Campaign Service BULLETIN

BULLETIN NUMBER:
SB00-11-8003

HEAD IMPACT PROTECTION SAFETY CAMPAIGN 00V-121

1999 Ro deo (UE) models with the following VIN Range: X4300040 - X4384458

Figure 10: Attach "Hose O-Flex Plate Assembly."

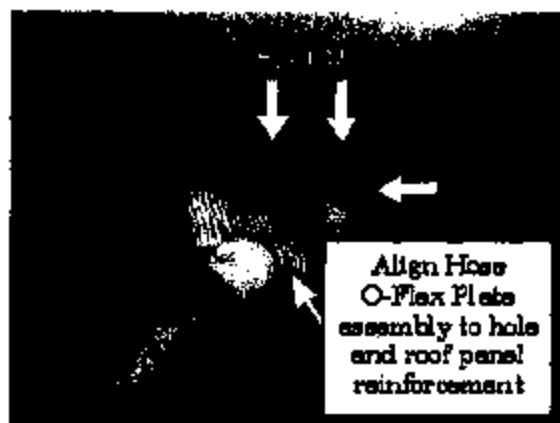
5. Remove sunroof switch (if equipped) and slightly lower the headliner.
6. Wipe and clean the contact area of the A-Pillar inner panel, inner rail, and roof panel reinforcement with alcohol wipe. (Figure 7 & 9)
7. Pull adhesive backing of "Hose O-Flex Plate Assembly" and install to roof panel reinforcement, by slightly lowering the headliner. (Figure 9 & 10)

To remedy this condition, remove and replace with a new Driver and Passenger A-Pillar Trim Cover, add a new Driver and Passenger Upper Spacer Assembly, Hose O - Flex Plate Assembly, A-Pillar Finisher, and Sun Visor Plate and Washer.
